**RESOLUTION No. 13/14-5
CITY OF DAYTON, OREGON**

Title: A Resolution Adopting Public Works Design Standards Update No. 6

TO: All Holders of Public Works Design Standards (PWDS) for the City of Dayton

SUBJECT: Public Works Design Standards Update No. 6 (DRAFT)

LAST REVISION DATE: NOV 2013	COPYRIGHT 1996 WESTECH ENGINEERING, INC.
30' RESIDENTIAL STREET (LOCAL 1 CLASS) MINIMUM SECTION (NTS)	
DAYTON, OR	DETAIL NO. 201-1

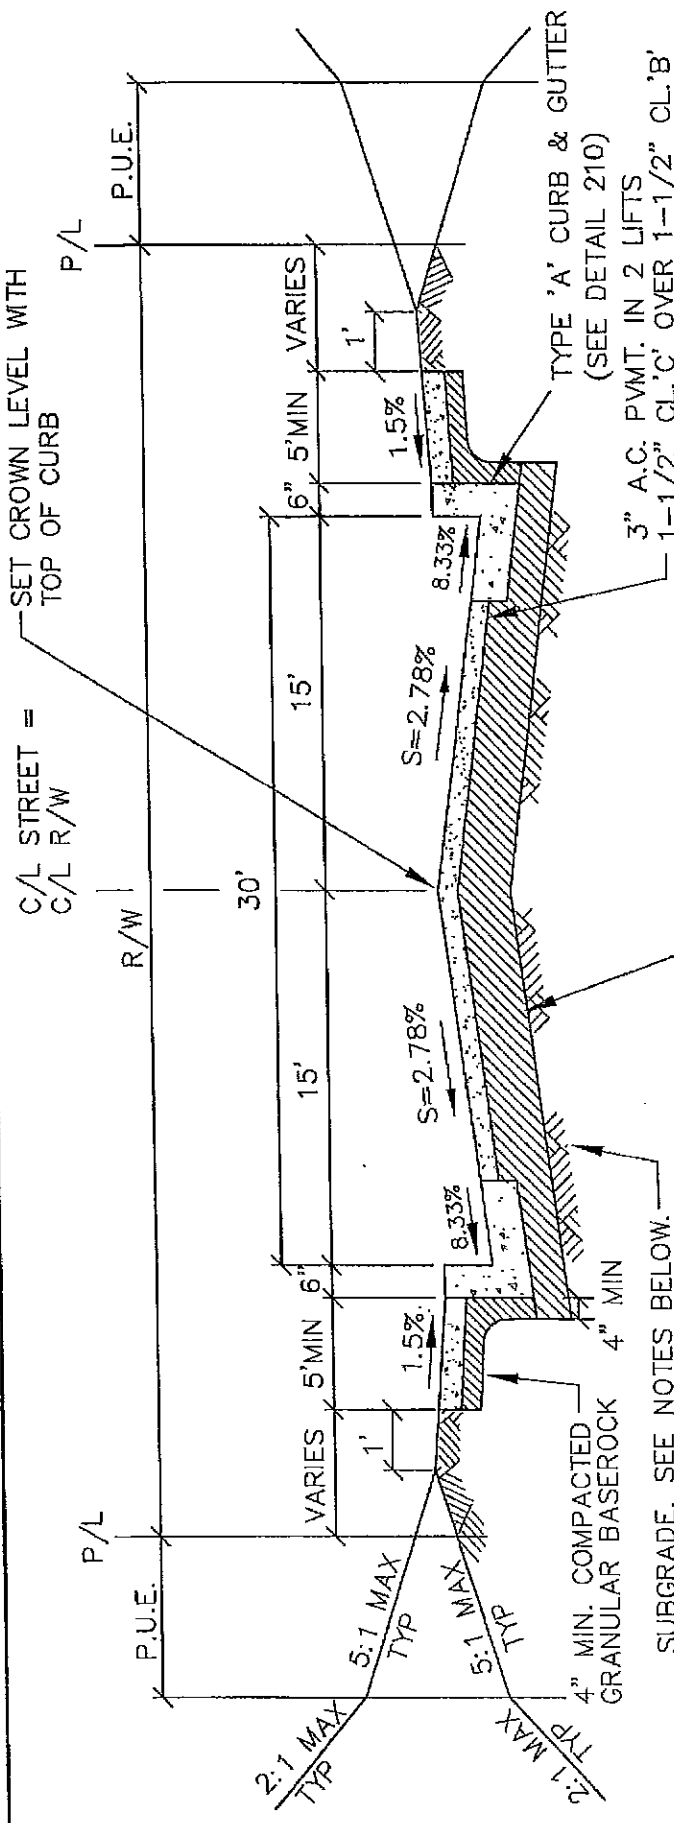
35. Sidewalk Cross Slopes. The changes discussed above (regarding sidewalk ADA compliance) applies to the sidewalk cross slopes listed on Details 201-1, 201-201-3, 202, 203, 204, 212, 212A, 213, 216, 237 and 238. The revised details (see attached) are dated 11/13.
36. Detail 213A: Notes modified to clarify that the typical clearance shown from the back of curb may be modified by the City based on actual sidewalk widths. The revised detail (see attached) is dated 11/13.
37. Detail 301: Note modified to clarify the trench width listed is based on standard trench boxes set on the trench bottom. The revised detail (see attached) is dated 9/13.

LAST REVISION DATE: SEPT 2012	
AC STREET CUT FOR STREET WIDENING OR EXTENSION (NTS)	
DAYTON, OR	DETAIL NO. 302B

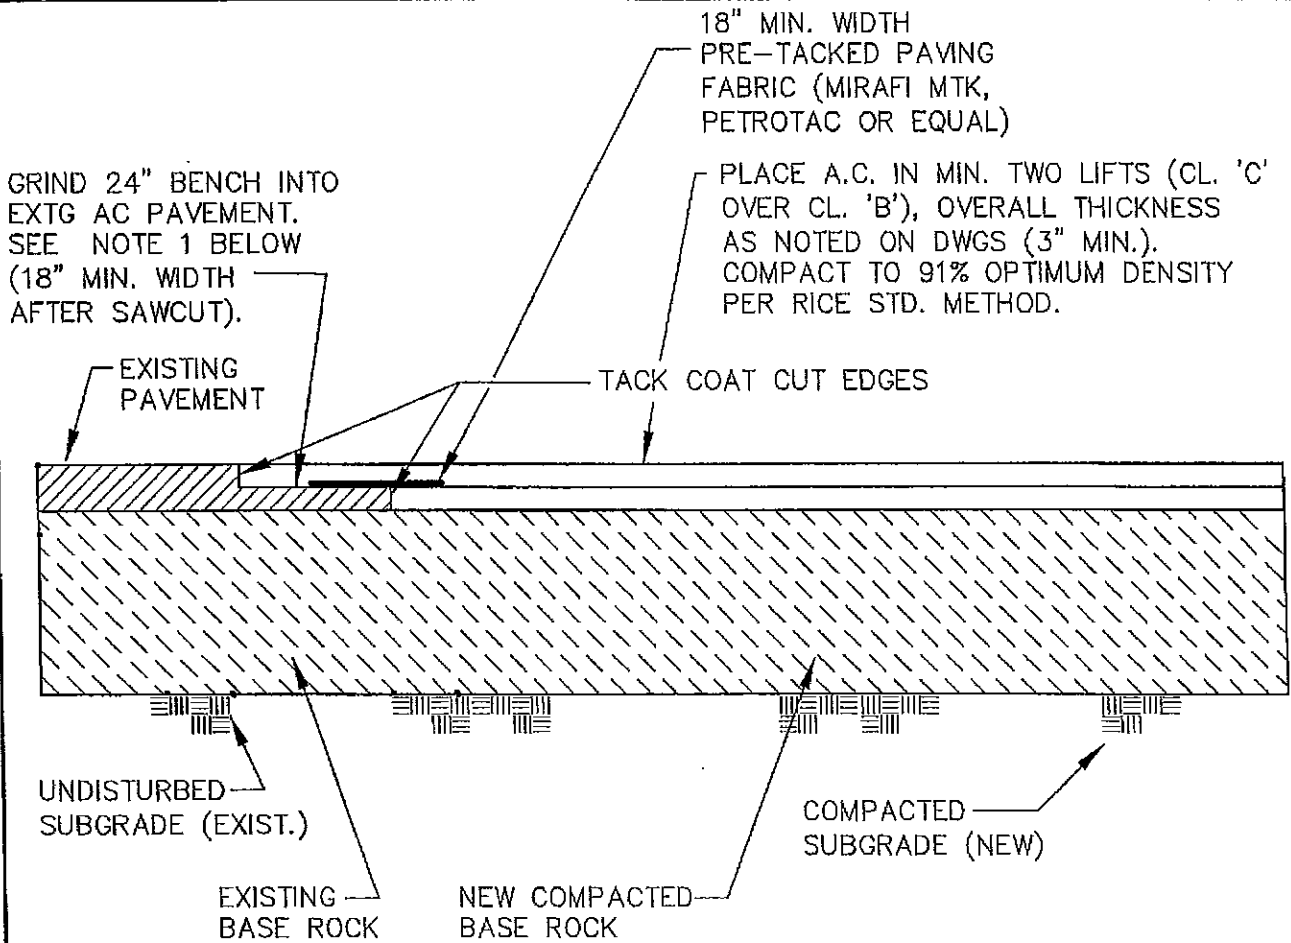
38. Detail 302B: The detail title was modified to clarify that this joint is required for either street widening or street extensions. The revised detail (see attached) is dated 9/13.

LAST REVISION DATE: JULY 2013	
GRAVEL SURFACE RESTORATION	
(NTS)	
DAYTON, OR	DETAIL NO. 303

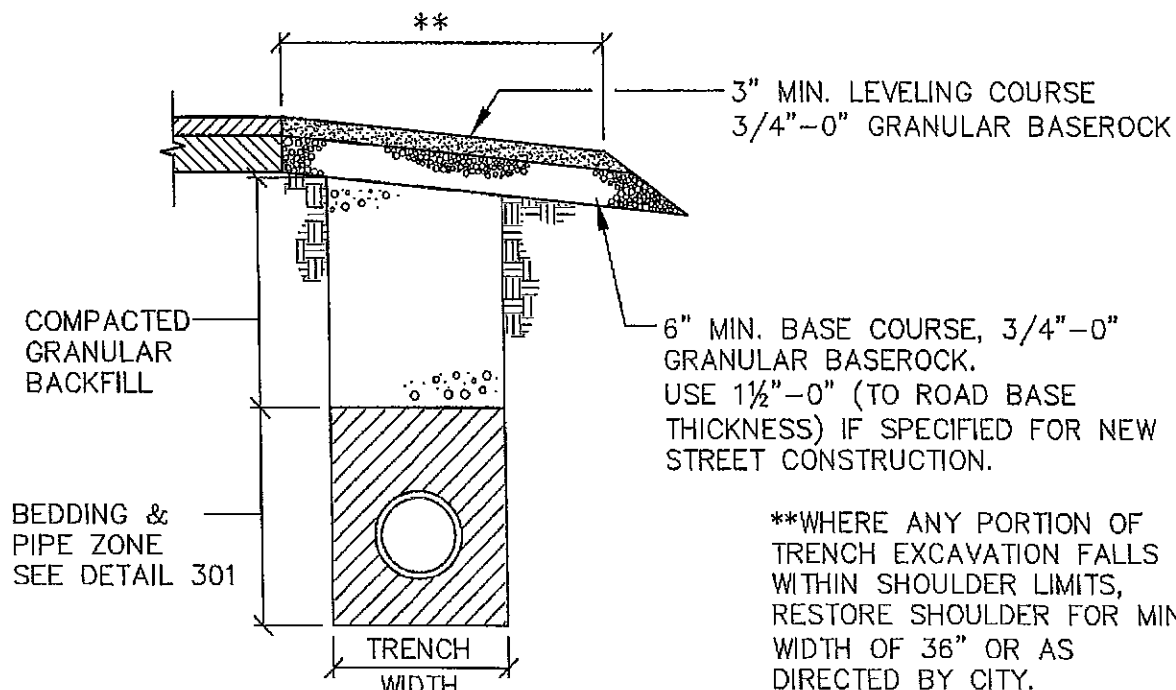
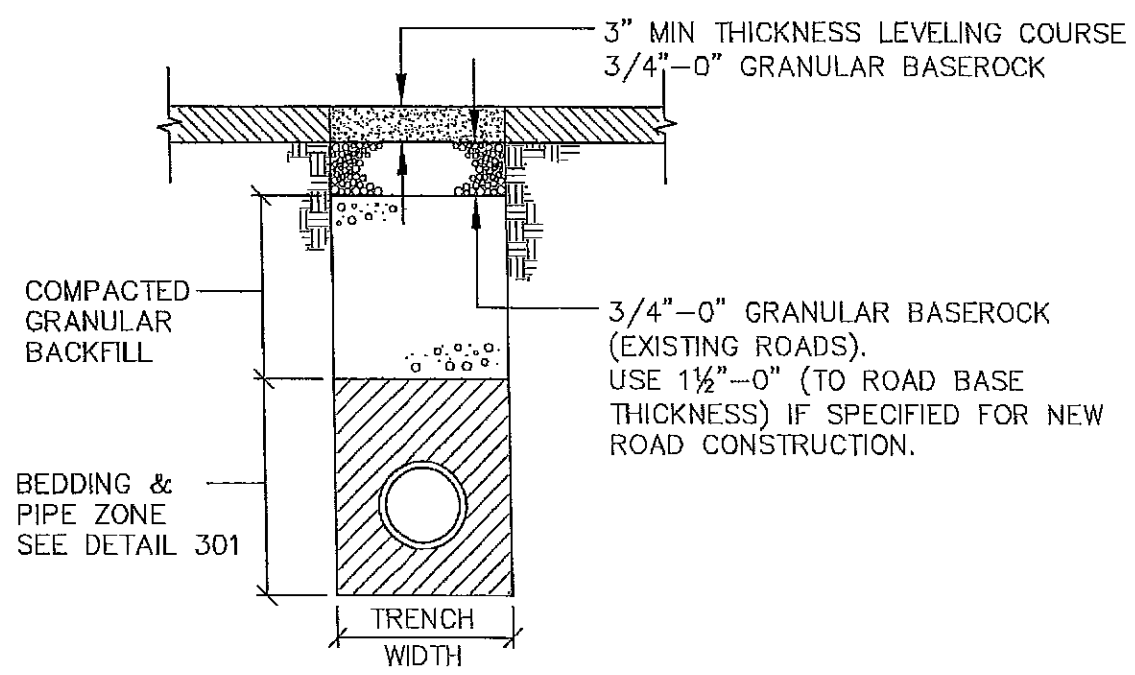
39. Detail 303: The detail callouts were modified to clarify the type of baserock for use in the top of the trench for existing and new streets. The revised detail (see attached) is dated 7/13.

LAST REVISION DATE: NOV 2013	JD #
MANHOLE RIM ADJUSTMENT DETAILS	
(NTS)	
DAYTON, OR	DETAIL NO. 407

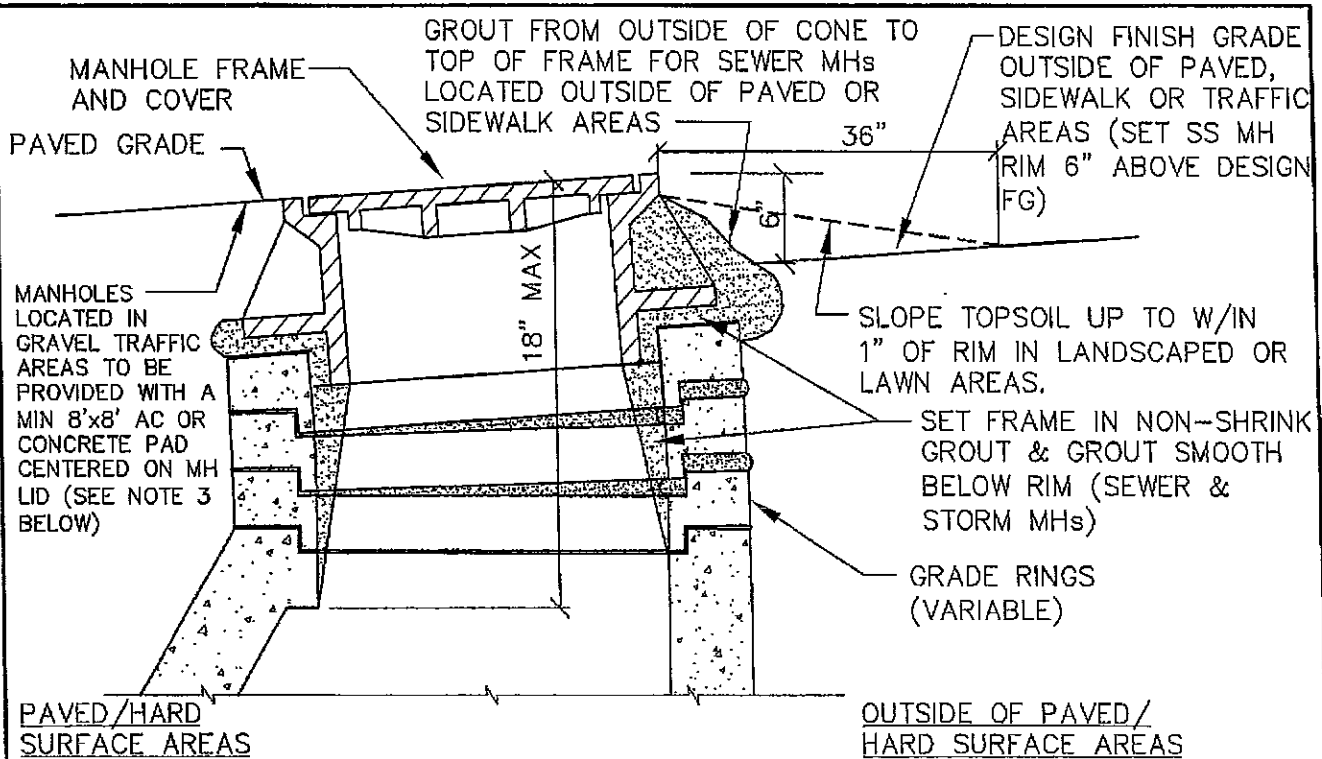
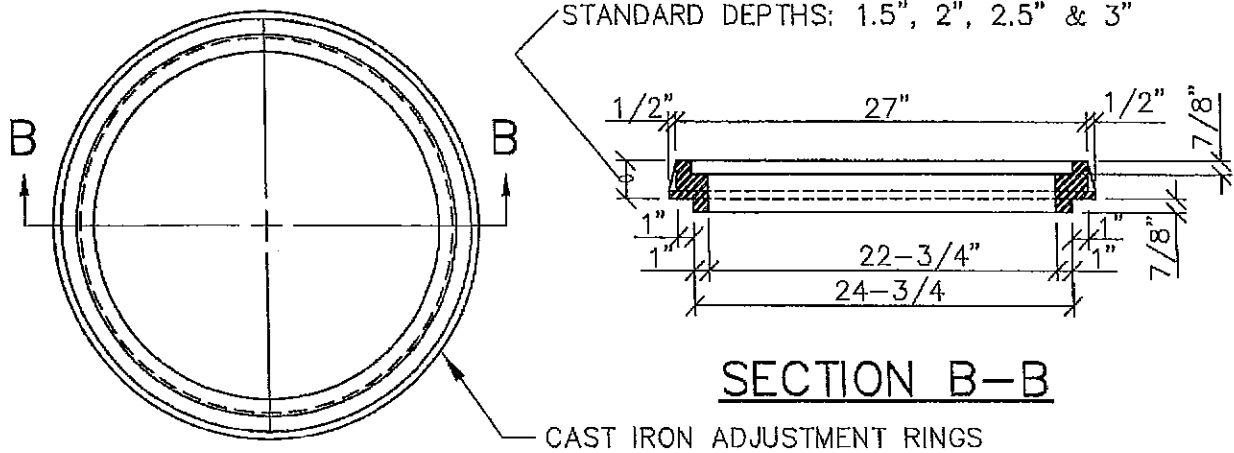
40. Detail 407: The drawings notes were modified to reference the note relating to thickness of the AC or concrete pad required around manholes in unpaved traffic areas. The revised detail (see attached) is dated 11/13.

LAST REVISION DATE: SEPT 2013		COPYRIGHT 1998 HST/CH ENGINEERING, INC.	
SEWER AND STORM SERVICE LATERALS			
(NTS)			
DAYTON, OR		DETAIL NO. 415

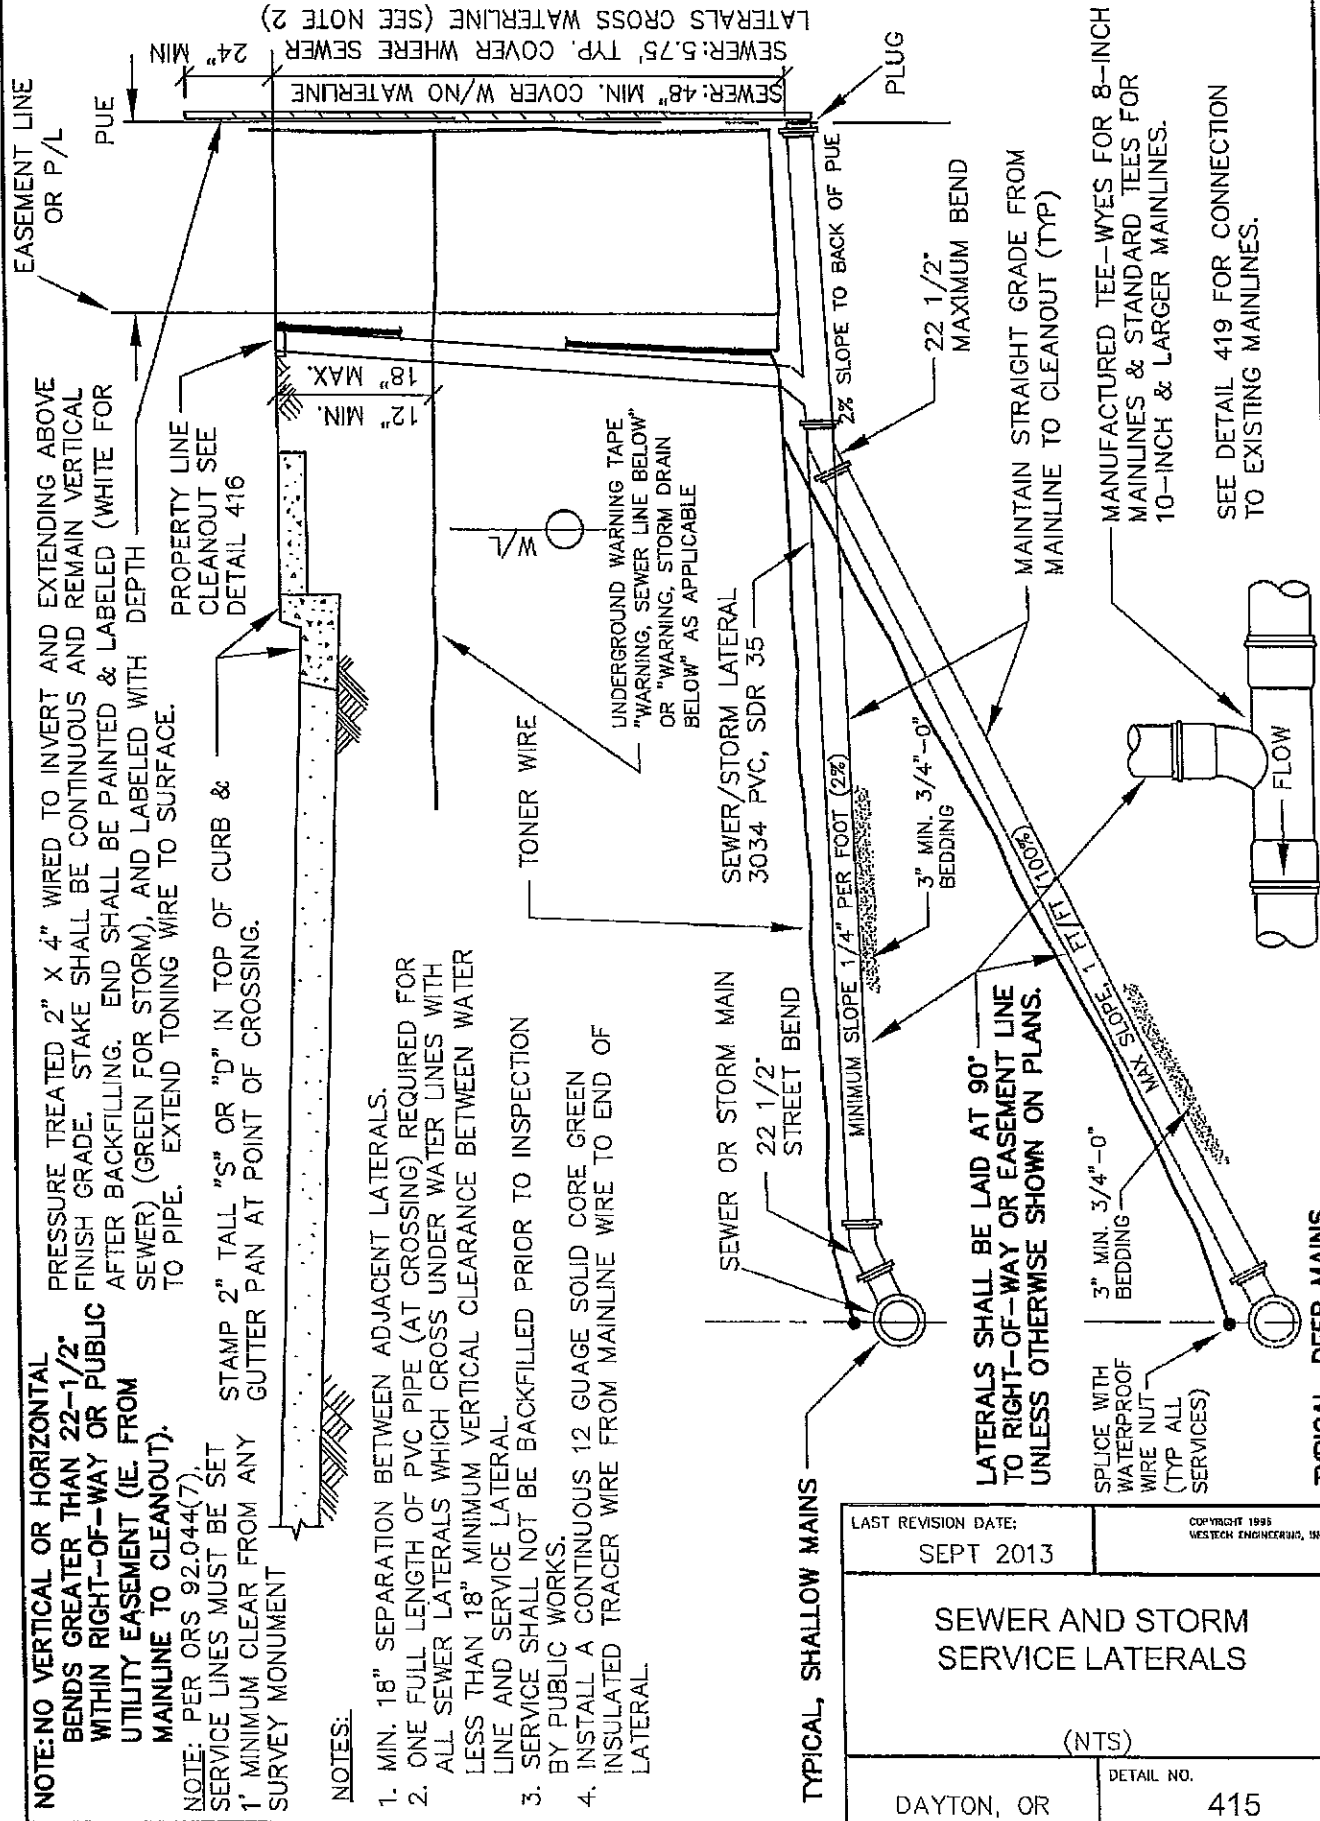
41. Detail 415: The detail was modified to more clearly show the configuration of the cleanout riser pipe and to clarify fittings allowed from the mainline to the cleanout. The revised detail (see attached) is dated 9/13.

LAST REVISION DATE: SEPT 2013	COPYRIGHT 1996 WESTECH ENGINEERING, INC.
STANDARD SERVICE LATERAL CLEANOUT	
(NTS)	
DAYTON, OR	DETAIL NO. 416

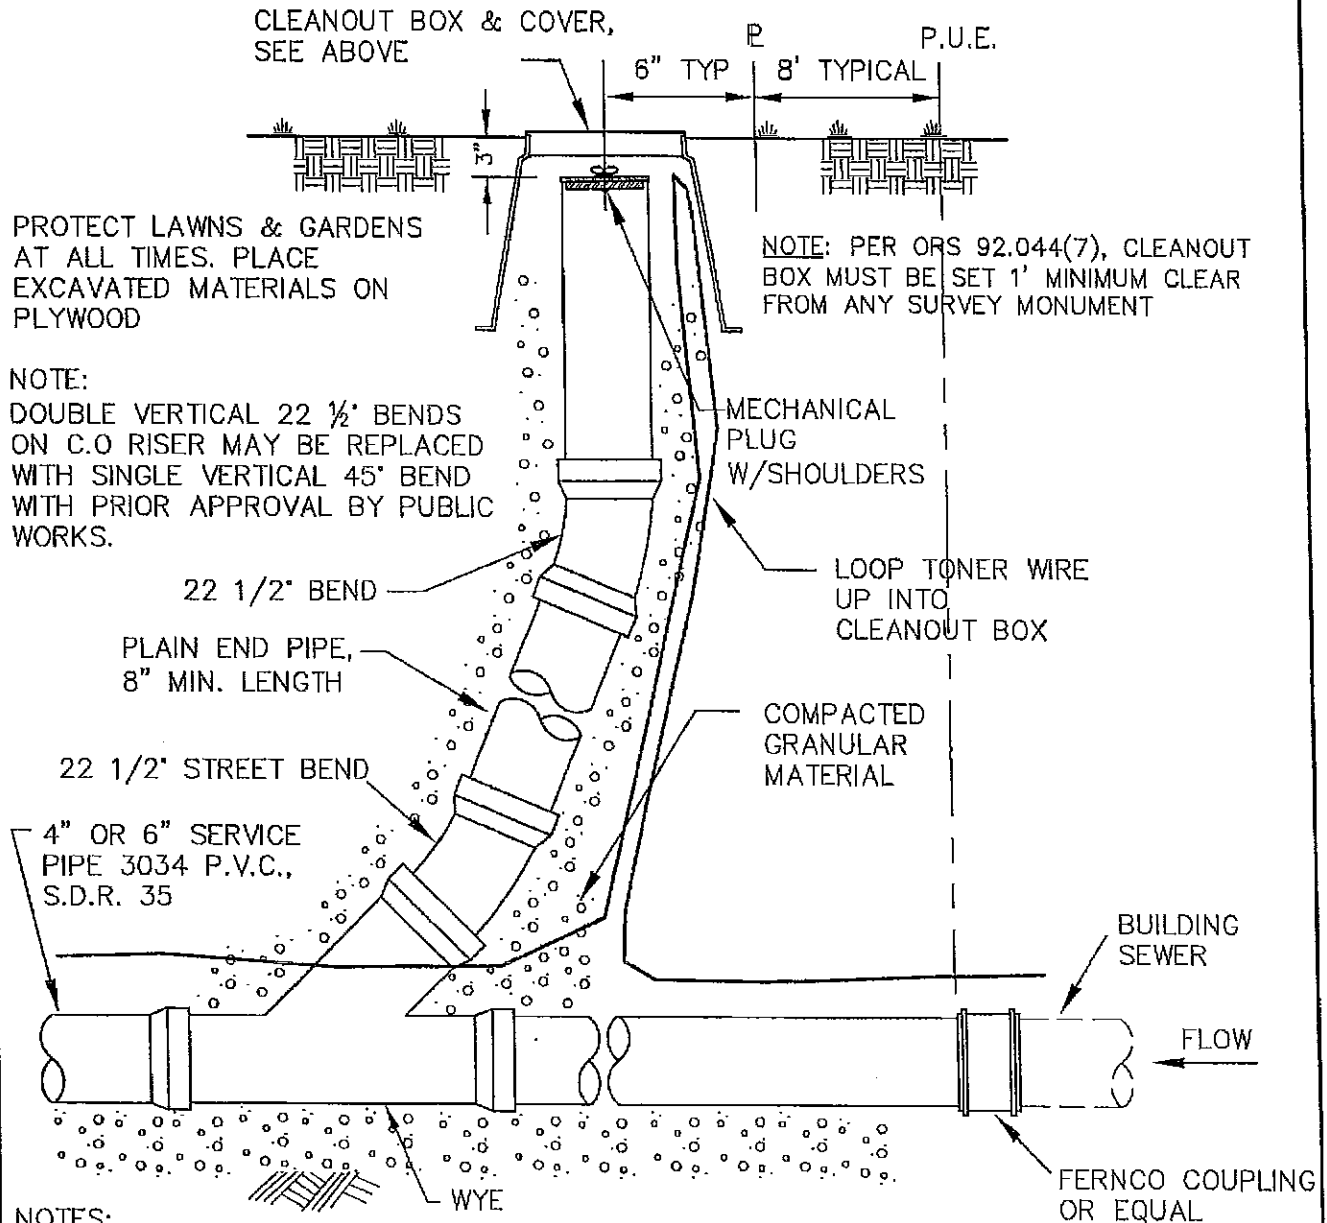
42. Detail 416: The detail notes were modified to clarify the fittings which can be used on the cleanout riser with approval by Public Works. The revised detail (see attached) is dated 9/13.
